Economic Commission for Europe
Inland Transport Committee
World Forum for Harmonization of Vehicle Regulations
Working Party on Lighting and Light-Signalling
Eighty-first session

Geneva, 15–18 April 2019

Report of the Working Party on Lighting and Light-Signalling on its eighty-first session
Contents

Headlamp mounting height (m)

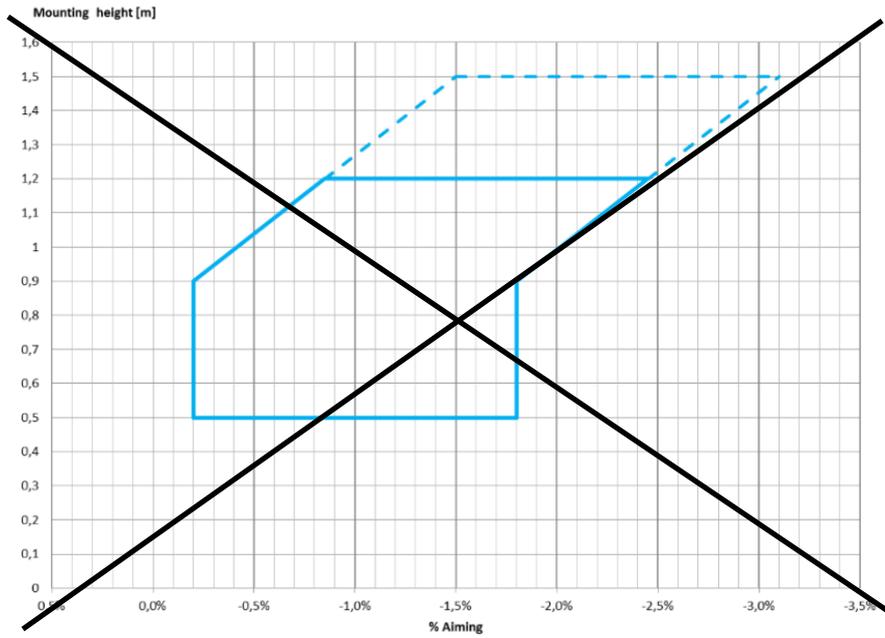
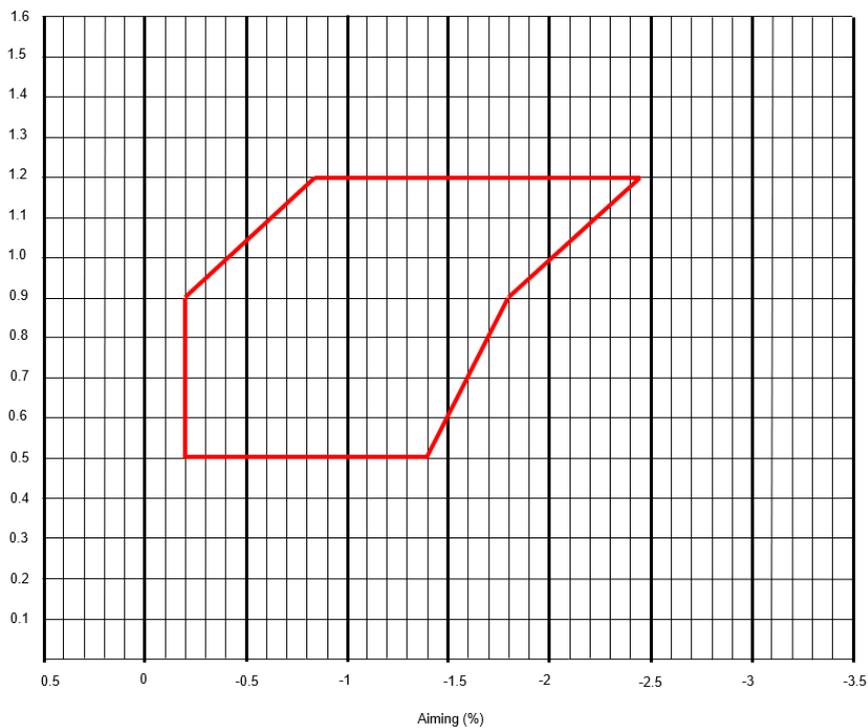
10. The expert from IWG SLR presented a proposal for a new 07 series of amendments to UN Regulation No. 48 (ECE/TRANS/WP.29/GRE/2019/3). The expert from Poland commented on the proposal (GRE-81-13 and GRE-81-16). GRE focused its discussion on the aiming diagram in paragraph 6.2.6.1.2. Following an in-depth consideration, GRE agreed on a modified diagram (GRE-81-21 and Annex II) and requested IWG SLR to prepare, on the basis of the new diagram, a revised proposal for consideration at the next session. The experts from Germany and Poland made study reservations. The expert from Germany also pointed out that, at the next session, he would present the outcome of a research project on the issue.

Paragraph 6.2.6.1.2., replace the blue figure by the figure in red:
